March 19, 2008

**Re: Cellco Partnership d/b/a Verizon Wireless Proposed Wireless
Telecommunication Facility, 199 Town Farm Road**

Re: Telecommunications Facility for Verizon Wireless
199 Town Farm Road

DESIGN: DIVERSION AND ACCESS ROAD
 PREPARED FOR: SIMMONS FARM
 PREPARED BY: NATURAL RESOURCES CONSERVATION SERVICE; WINDSOR, CT.
 IN COOPERATION WITH: NORTH CENTRAL CONSERVATION DISTRICT
 DRAWING NO.: CT-01-H-07-01
 ENGINEERING JOB CLASS I

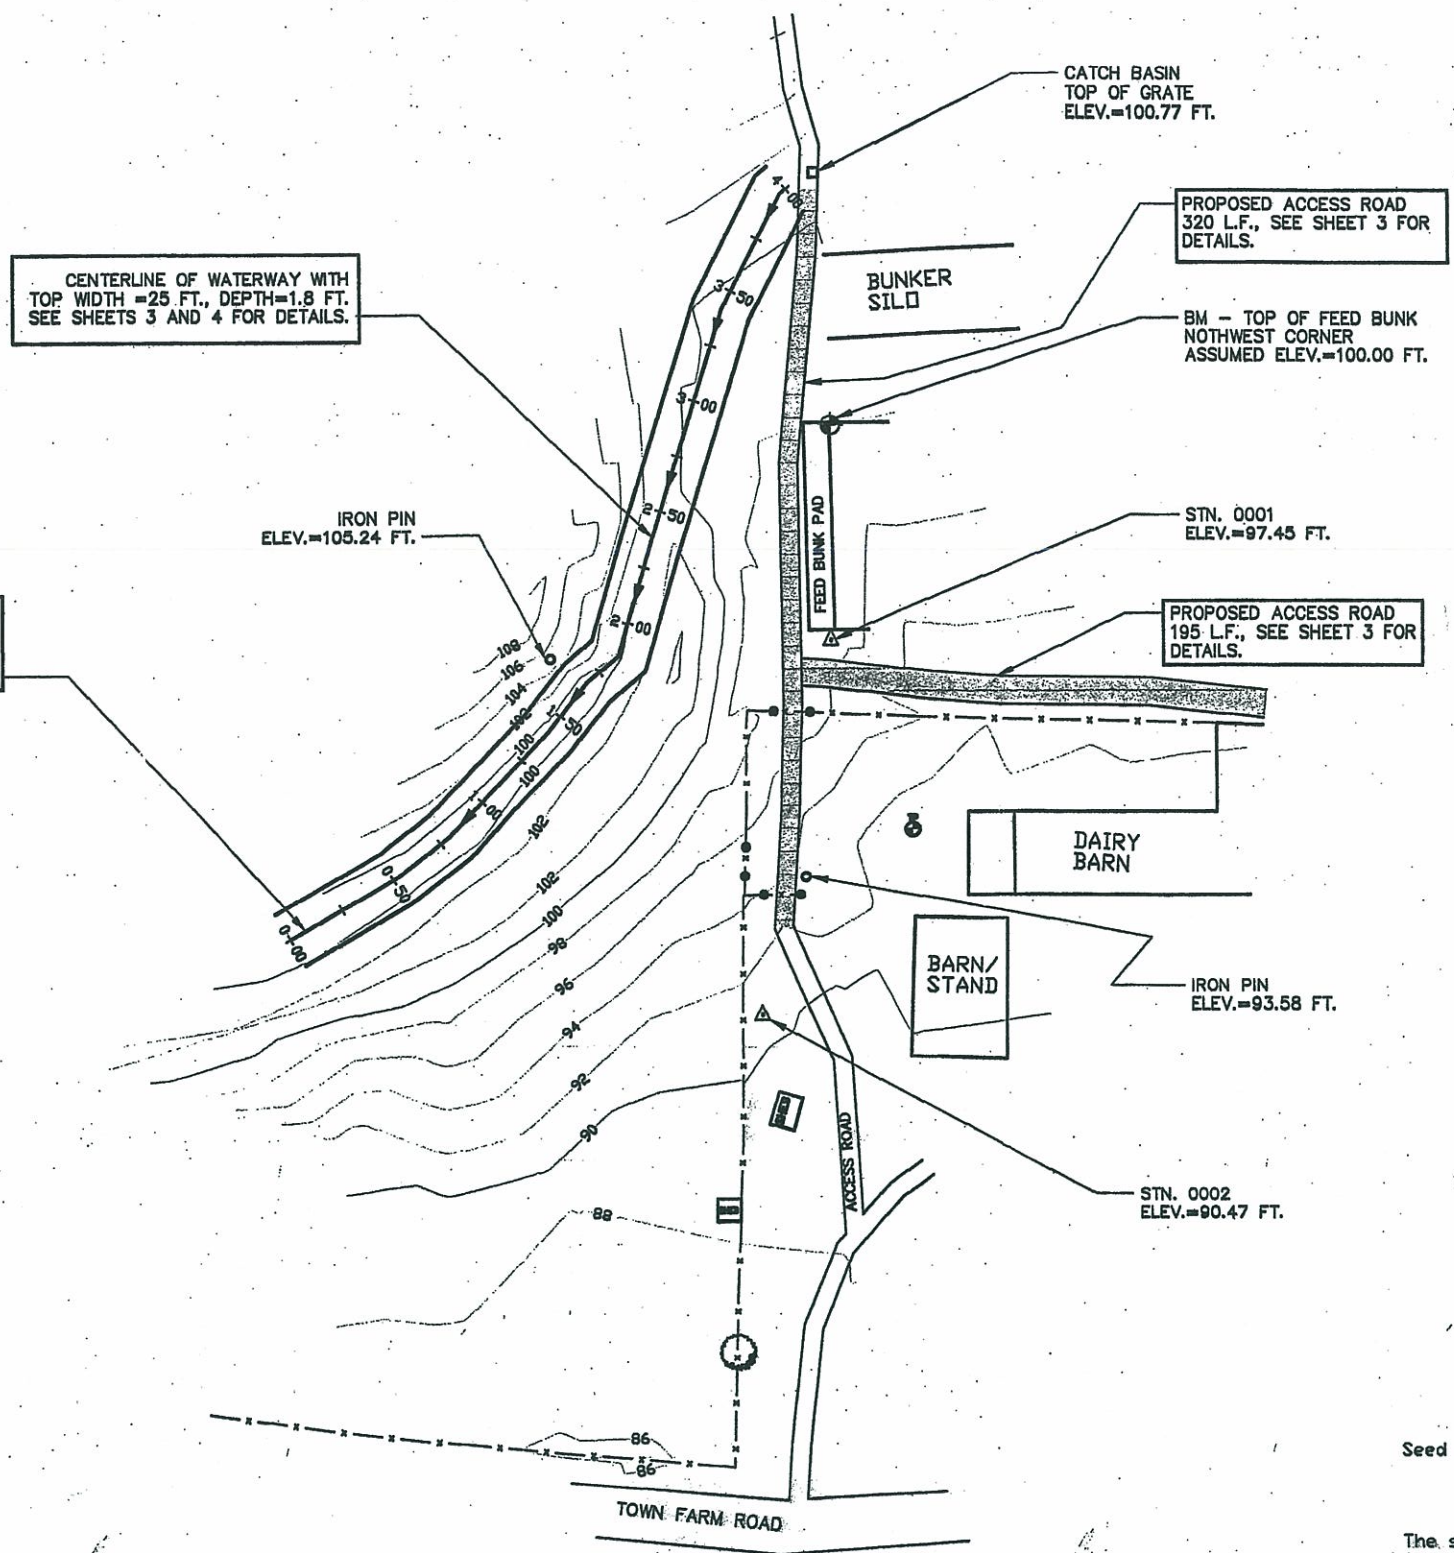
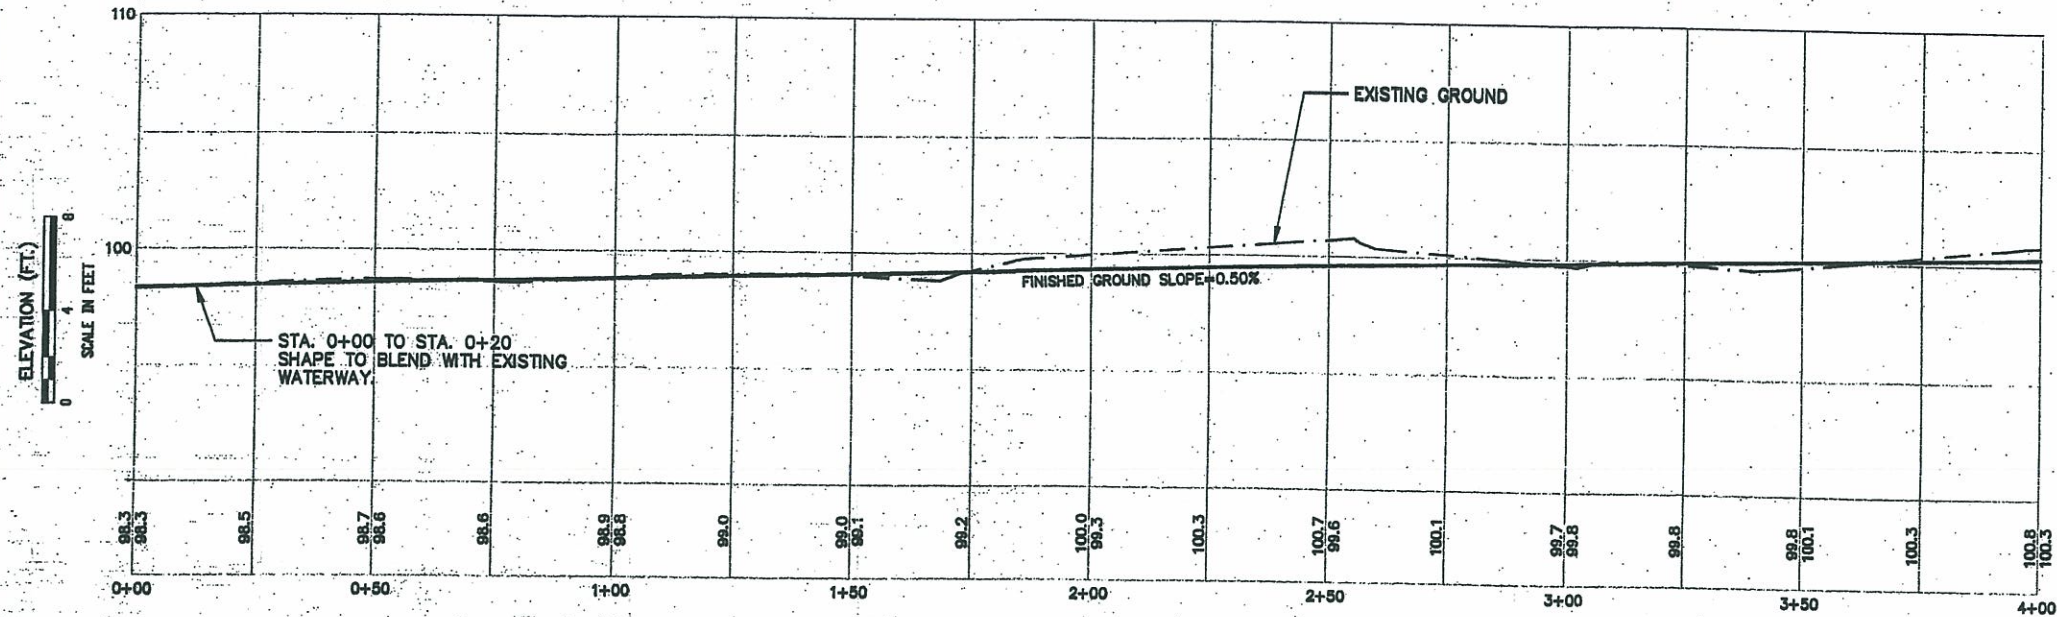
Mr. Simmons also raised concerns about the impact of the construction of the access road on plans by the U.S. Department of Agriculture (USDA) to install diversion ditches on the property. Representatives from Cellco's engineering firm, URS Corporation (URS), have spoken with both the USDA and Mr. Simmons regarding these concerns and have obtained copies of the plans for these ditches. Based on these conversations and a review of the plans (copy attached), Cellco has determined that the construction of the access road associated with Cellco's proposed wireless telecommunications facility will not disrupt or in any way interfere with the construction, operation or maintenance of the diversion ditches.

1. Legality of double leasing farm property.
2. Maintenance of road leading to tower. Who is going to maintain it and how? Cattle are moved around in that area. If cows consume salt, they die. The town has signed a contract with the Federal Government to put in diversion ditches in this same area.
